Item Name: Crosstube Turning Detail

DART AEROSPACE LTD	Work Order: 109061
Description: Crosstube Assembly (412 Low Aft)	Part Number: D412-664-249
Inspection Dwg: D412-664-249 Rev: B	Page 1 of 2

DRAWING NO. D412-664-249	TITLE CROSSTUBE ASS'Y (412 LOW AFT)	REV. B	DART AEROSPACE LTD ENGINEERING ORDER		D.E.O. NO. D412-664-249-B-1	SHEET NO. SHEET 1 OF 2	SCALE NTS
DRAWN <i>qp</i>	CHECKED <i>Sc</i>	MFG. APPR. <i>E</i>	APPROVED <i>MD</i>		DE APPR. <i>MD</i>		
DATE 11.05.25	DATE 11.05.31	DATE 11.05.31	DATE 11/05/31		DATE 11.05.31

DRAWING NO. D412-664-249	TITLE CROSSTUBE (412 LOW AFT)	REV. B	DART AEROSPACE LTD ENGINEERING ORDER		D.E.O. NO. D412-664-249-B-3	SHEET NO. SHEET 1 OF 3	SCALE NTS
DRAWN <i>q</i>	CHECKED <i>h</i>	MFG. APPR. <i>h</i>	APPROVED <i>h</i>	DE APPR. <i>h</i>			
DATE 12.08.21	DATE 12.08.30	DATE 12.08.30	DATE 12.08.30	DATE 12.08.30	DATE 12.08.30

**D412-664-249
ASSEMBLY DETAIL**

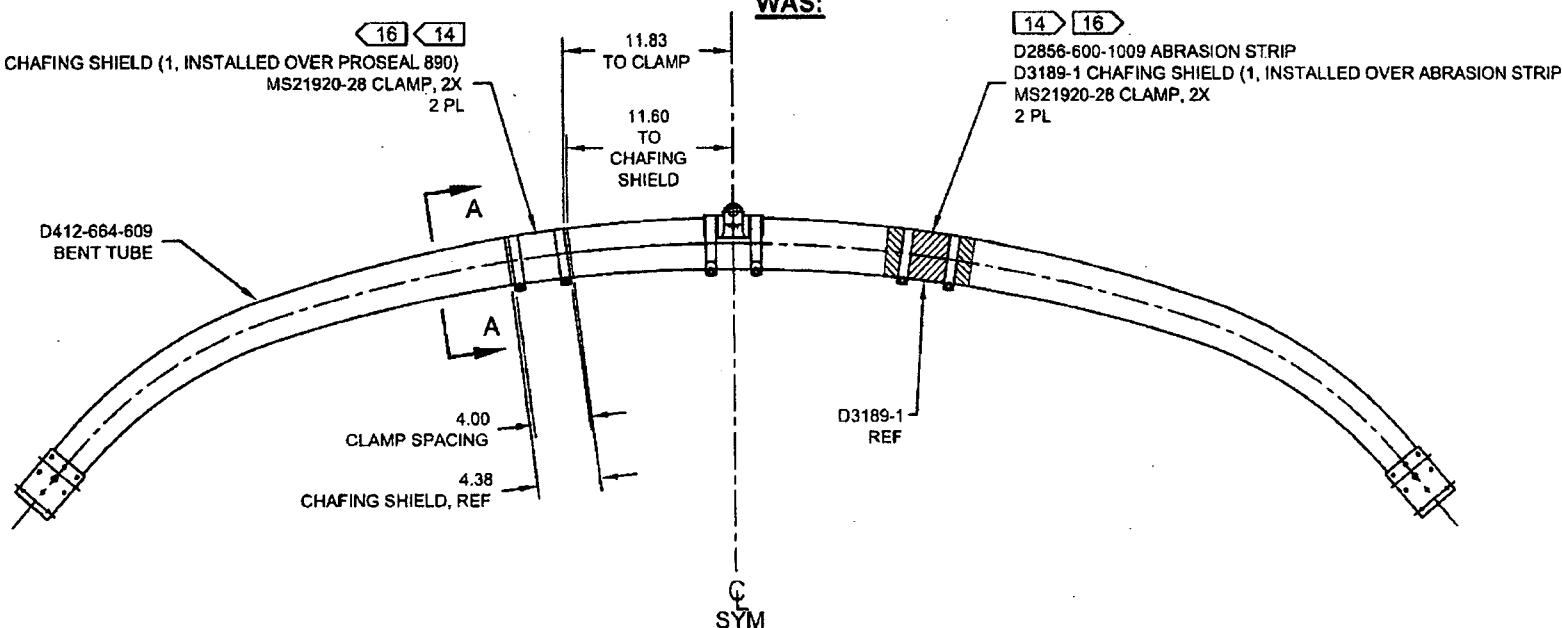
PURPOSE:

REMOVED ABRASION STRIP IN FAVOR OF A THIN LAYER OF PROSEAL 890. UPDATE INSTALLATION OF CHAFING SHIELDS AND REDUCE TORQUE TO 40-50 IN-LBS. THIS ENGINEERING ORDER SUPERCEDES DEO D412-664-249-B-1

IS:

D3189-1 CHAFING SHIELD (1, INSTALLED OVER PROSEAL 890)
MS21920-28 CLAMP, 2X
2 PL

WAS:

D2856-600-1009 ABRASION STRIP
D3189-1 CHAFING SHIELD (1, INSTALLED OVER ABRASION STRIP)
MS21920-28 CLAMP, 2X
2 PL
